PROJECT OPERATIONS PLAN
FOR
THE REMEDIAL INVESTIGATION AND FEASIBILITY STUDY
Mid-Atlantic Wood Preservers Site
Harmans, Maryland

Addendum to Volume I
Work Plan

November 13, 1987

FIGURE 1
PROPOSED MONITORING WELL LOCATIONS

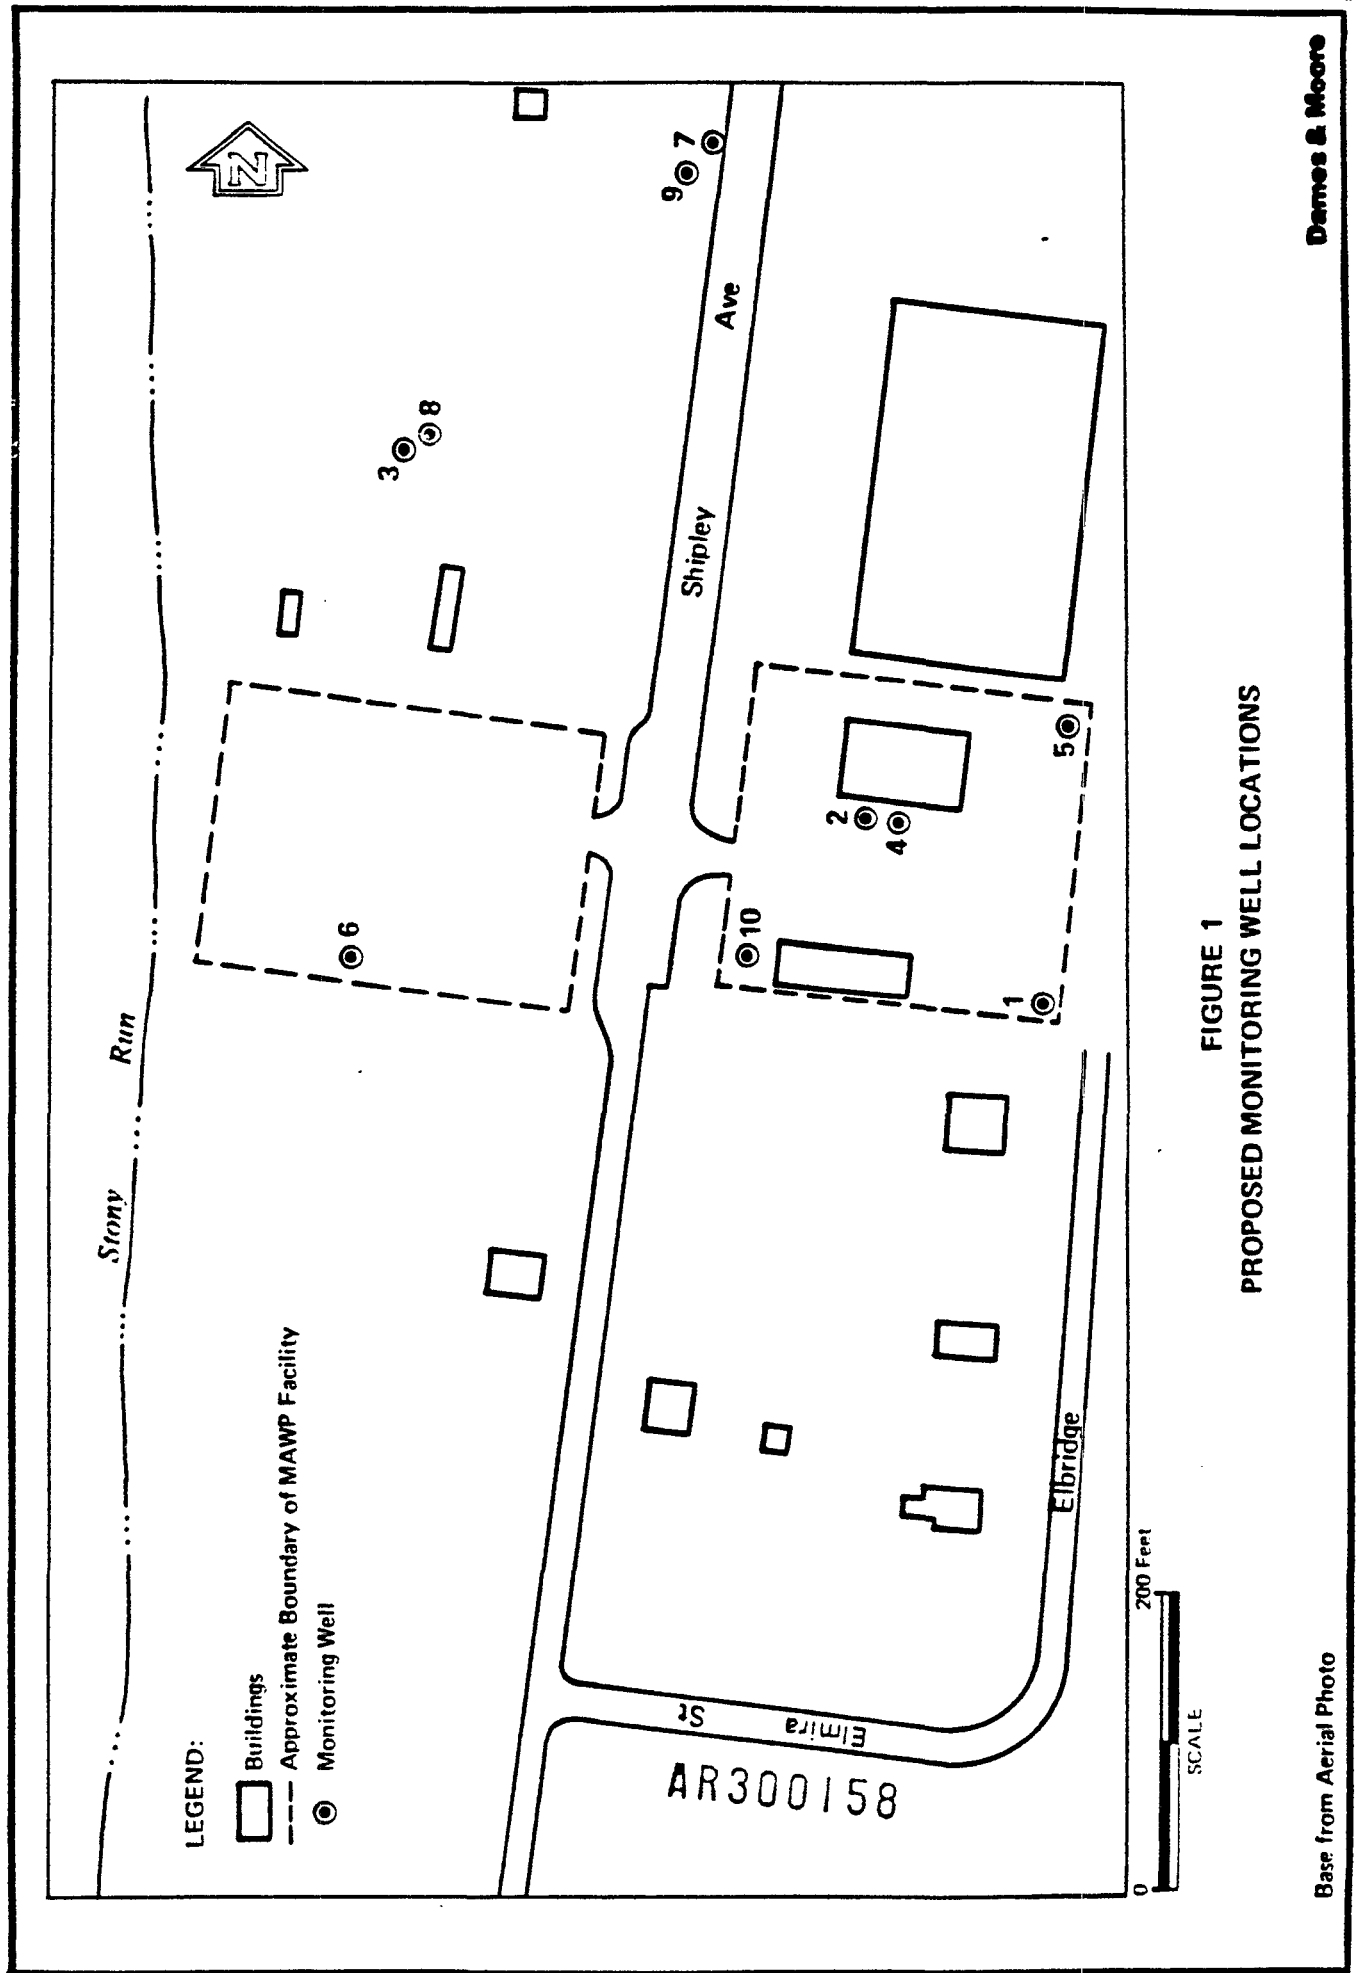
4) The modified well locations are shown in Figure 1. They include a well in the drip pad area a deep well adjacent to proposed well #2 and a well in the southwest corner of the eastern half of the facility.

2) We agree that due to the uncertainty of the direction of current groundwater flow, well locations should be selected so as to investigate assumed upgradient as well as downgradient locations. This is reflected in the modified proposed monitoring well locations shown in Figure 1 and discussed in the response to the State's comment number 4. The extent to which Stony Run serves as a hydraulic boundary will be determined by the use of stream gauging and flow net construction. The discharge of the stream will be measured at one location up stream from the facility, and at one location downstream. The difference in discharge between the 2 locations, divided by the length of stream between the locations, will allow a determination of the rate of groundwater discharge to, or recharge from the stream to be made. This information, along with the piezometric surface data collected from water level measurements in the proposed wells, will allow a flow net to be constructed. The flow net is a cross section of the stream and aquifer showing the lines of flow of the groundwater, and the approximate depth to which the stream acts as a hydraulic boundary. Details of the method to measure stream discharge, such as the technique to be used and measurement locations, will be described in detail in the Site Operations Plan.

4) Proposed monitoring well locations have been modified as indicated in Figure 1. Wells 4 and 5 originally proposed to be located near Stony Run have been relocated closer to the assumed source of contamination. Wells 3 and 8 remain in the same direction from the assumed source as the original locations of wells 4 and 5, and in this respect, the original proposed locations for wells 4 and 5 were redundant. Well 4 is now located adjacent to well 2 at the location of the former spill and is proposed to be screened at a depth of from 70 to 80 feet to evaluate the potential for vertical migration of contaminants. Wells 5 and 6 have been relocated to near the northeast and southwest corners of the site, respectively, and

will be useful for evaluating if groundwater flow directions vary from the suspected northwest direction. Well 10 has been added at the southwest corner of the eastern half of the facility, and will indicate whether there is any groundwater flow to the south.

FIGURE 2
PROPOSED SOIL, SURFACE WATER, AND SEDIMENT SAMPLING LOCATIONS

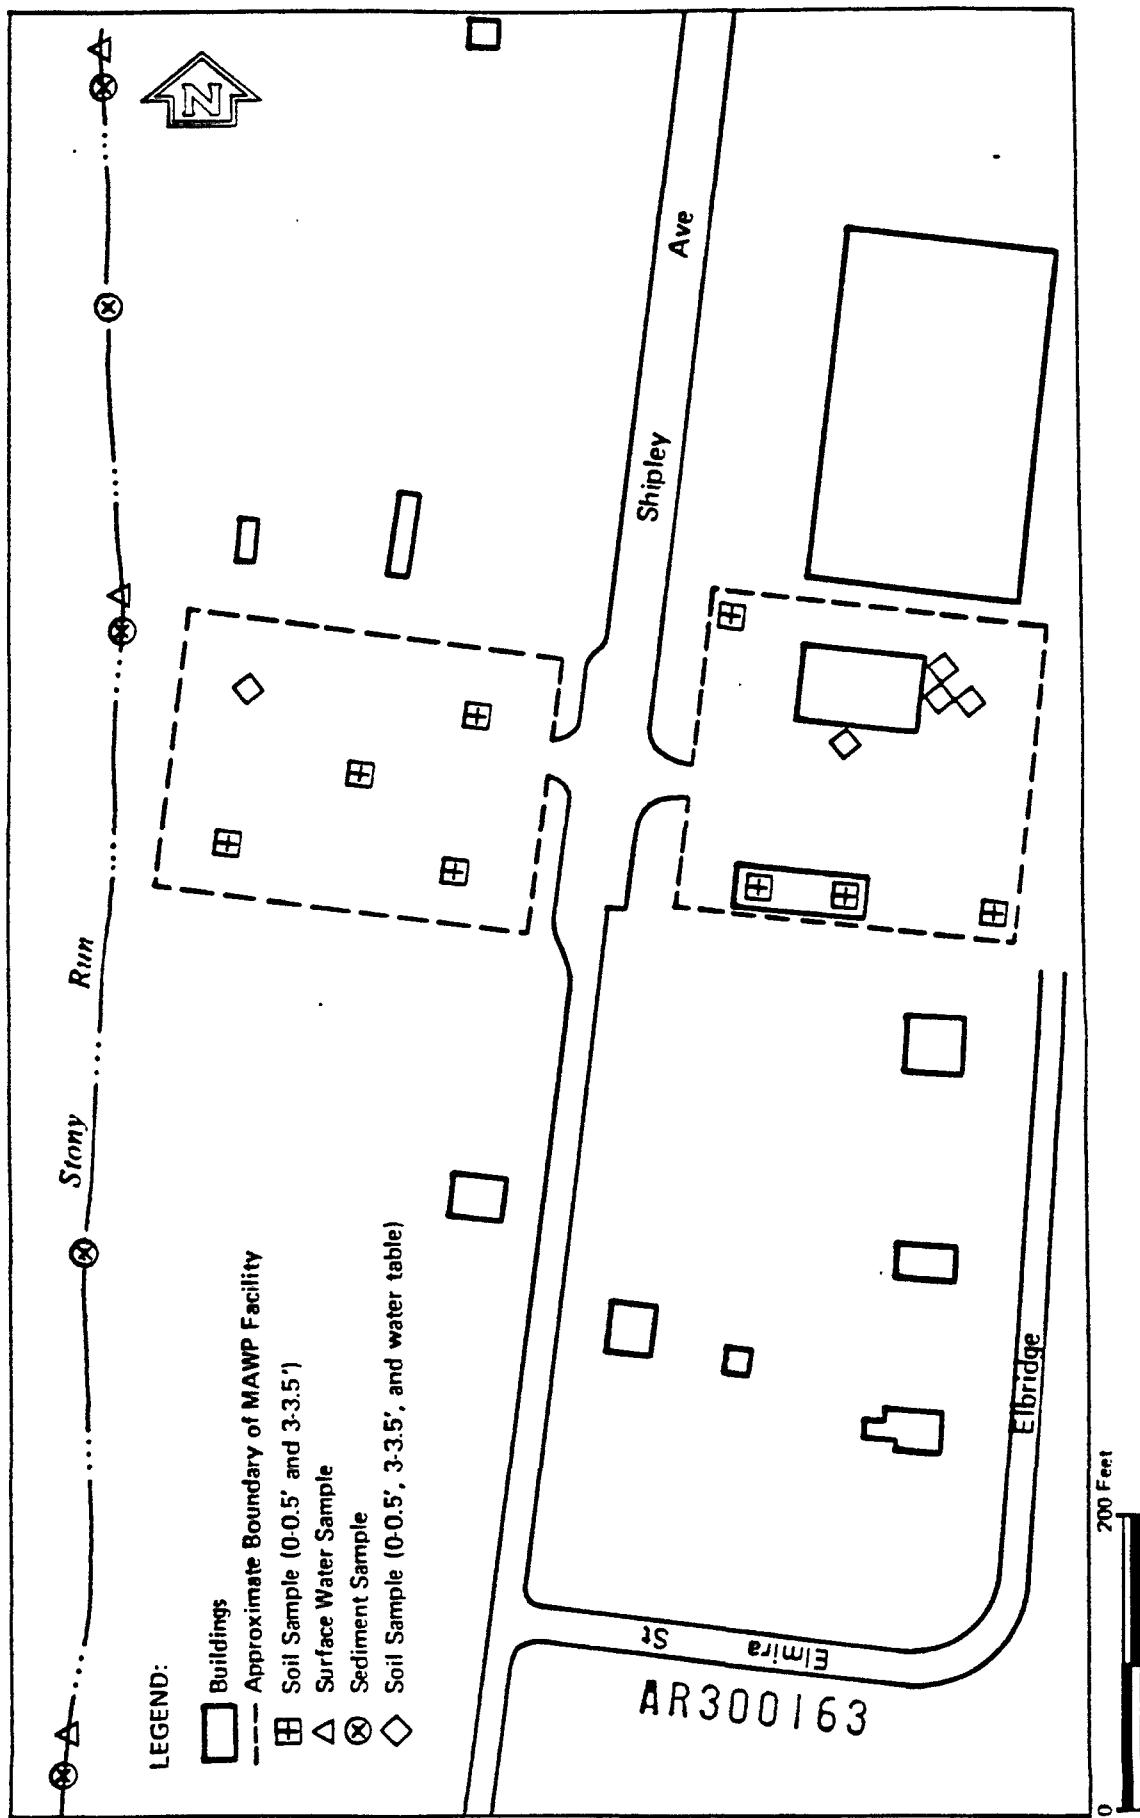
9) We propose that two additional sediment samples be collected from Stony Run at locations midway between the three initially proposed locations (see Figure 2). There have been 14 analyses of surface water from Stony Run for chromium, copper, and arsenic--only one of which had levels above detection (chromium, 0.22 ppm). The split of this sample was below detection. Stony Run is one continuously flowing stream along the 1,000+ feet of stream path near the MAWP facility. Therefore, three water samples will adequately determine if a surface water contamination problem exists.

Sampling locations have been revised, as shown in Figure 2, to cover a wider area and provide a more random sampling grid. Please note that samples from the three locations (six samples) near the drip pad have already been collected and analyzed for chromium, copper, and arsenic via EP toxicity extraction. Future testing for these metals will be by acid digestion to determine total concentrations. Soil samples will be collected for chemical analysis at depths of 0

to 0.5 and 3 to 3.5 feet at 13 locations. In addition, a soil sample composited from 2 feet above to 2 feet below the water table will be collected at 5 sampling locations. These locations will be the northwest corner of the site, near the former overflow pipe, and at 3 locations near the drippage collection pad. In addition, samples will be collected where visual evidence suggests that contamination is present.
